Agenda: Minnesota Committee on Uniform Traffic Control Devices

February 24, 2021 1:00 – 3:00

NPA Special Meeting

New Figure 3C-1 Crosswalk Markings:

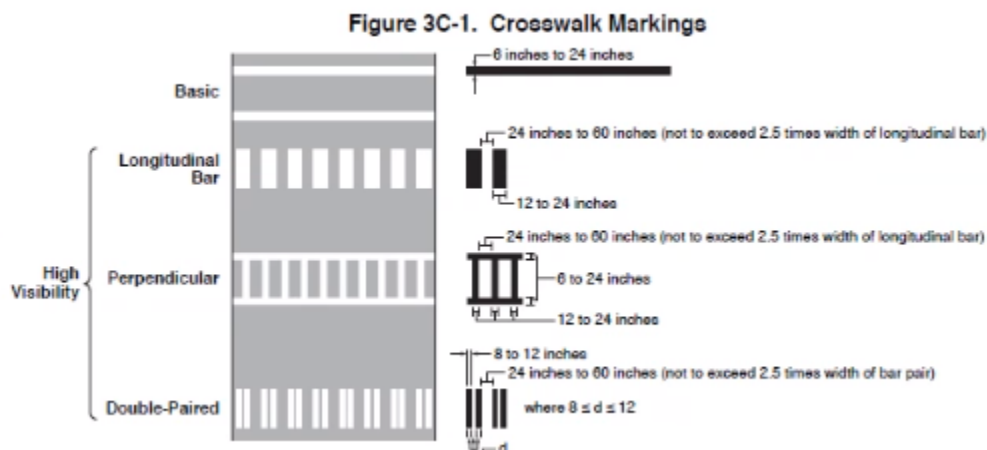
Discussion:

- MnDOT’s typical marking doesn’t meet these criteria. Line 39, page 371 of NPA – bar has to be 12-24 inches. MnDOT installs some up to 36”.
- Joe – we have started using the double-paired – instead of doing 3 x 6 blocks we’re staying on that same pattern but with 12” bars with 12” space between.
- Joe – line 40, change 2.5 to at least 3.

Motion to change page 371, line 37 to “The width of an individual longitudinal bar shall not be less than 12 inches or greater than **36**” (from 24”) made by Joe Gustafson, HunWen Westman seconded.
